Mt Piper Power Station Ash Placement Project

Submissions Report

**Mt Piper Power Station Ash Placement Project
Environmental Assessment
Application Reference: 09_0186**

SUBMISSIONS REPORT

- **Figure 2-2 Calculation of MHRDC multiplier (study point used to find harvestable right multiplier value indicated by arrow)**

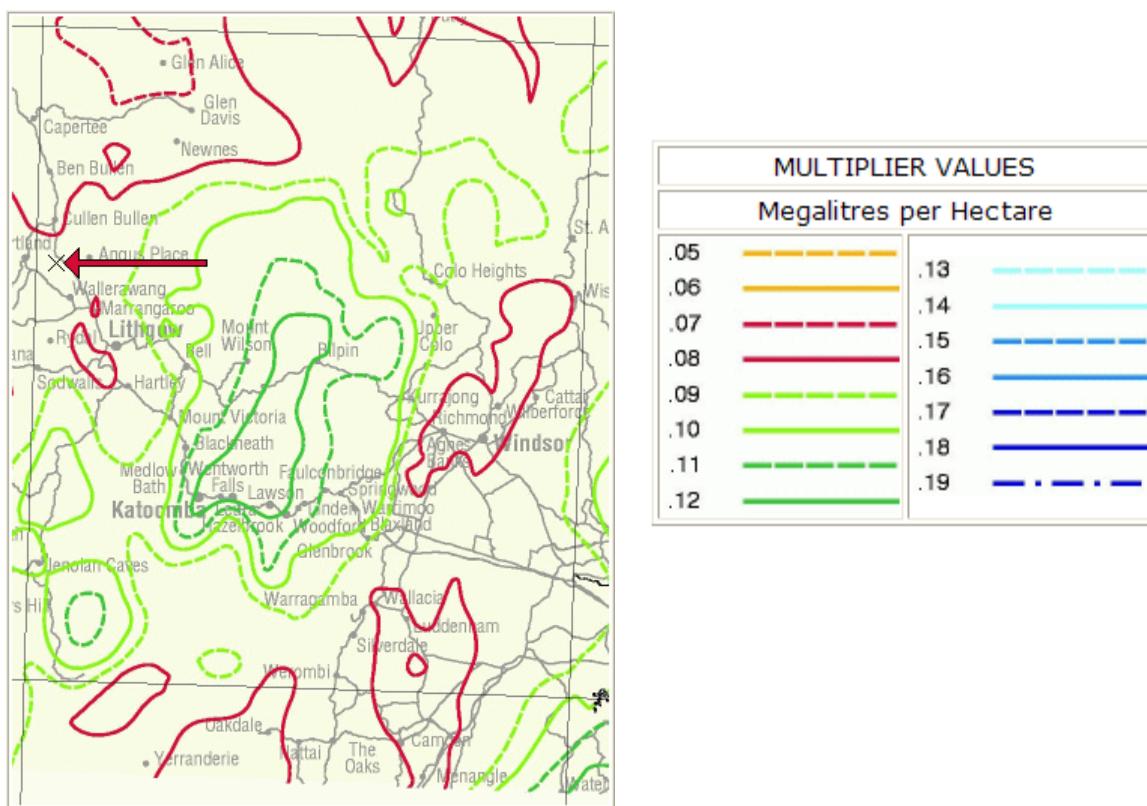
Climate data interpretation - The evaporation data presented in Figure 2-2 in Appendix D of the EA are based on evaporation from an open pan (Class A evaporation pan method), which is replenished on a daily basis. For this reason, Figure 2.2 represents evaporation as exceeding rainfall when in reality across the site it does not.

Additionally, although the Figure 2-2 shows the average evaporation exceeds average rainfall in 9 months of the year, the proposed ash placement facility will harvest rainfall runoff from across the catchments of the site, while the evaporation will be lost from water storages on the site. The water harvested from the catchments of the site will exceed the evaporation lost from the water storages at times throughout the year and therefore there will be water available on site to be used for dust

Catchment areas for Huons gully and Lamberts Gully are shown in Figure 3-2 of the EA. **Figure 2-2** and **Table 2-5** show the catchment areas together with calculated MHRDC for the site.
